Department of Energy

November 14, 1994

U.S. DOE Response to U.S. NRC Staff Comment and Questions Regarding the Quality Assurance Program for a High-Level Waste Repository, Letter dated October 13, 1994

**U. S. DEPARTMENT OF ENERGY RESPONSE
TO
U.S. NUCLEAR REGULATORY COMMISSION STAFF
COMMENT AND QUESTIONS REGARDING THE QUALITY ASSURANCE
PROGRAM FOR A HIGH-LEVEL WASTE REPOSITORY,
LETTER DATED OCTOBER 13, 1994**

ESP/REPOSITORY INTERFACE-INTEGRATED LAYOUT DESCRIPTION SC00000000-01117-0100-0000, REV 00, FIGURE 10-3

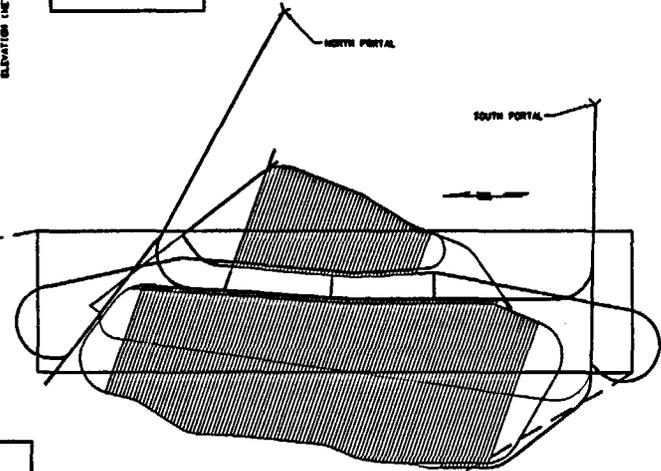
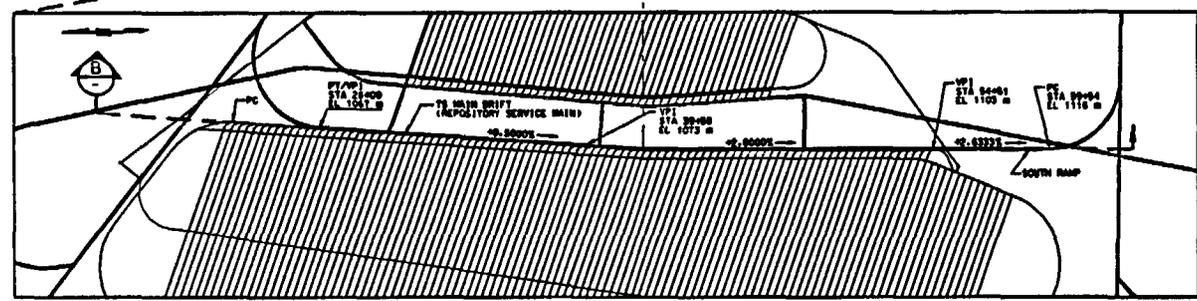
DOE should provide a description of the work, including design and construction, that will be completed in each phase of Design Package 2C. This information should relate the completion of construction to significant site features such as the Bow Ridge Fault, or issues raised on ESF construction such as pneumatic pathways.

The enhanced layout increases GROA design flexibility because the location of the TSL main drift adjacent and sub-parallel to the Ghost Dance Fault, and it being stratigraphically high in the TSw2 unit, (refer to ESF/GROA interface drawing, BC000000-01717-2100-89104, attached, for a cross-section view of the TSL Main Drift) make it is easier for the GROA designers to exclude this drift, if desired, from a potential repository if subsequent design work indicates that the drift is not useful. It should be emphasized that the TSL Main drift is currently intended to be part of the potential repository, if constructed at the Yucca Mountain site.
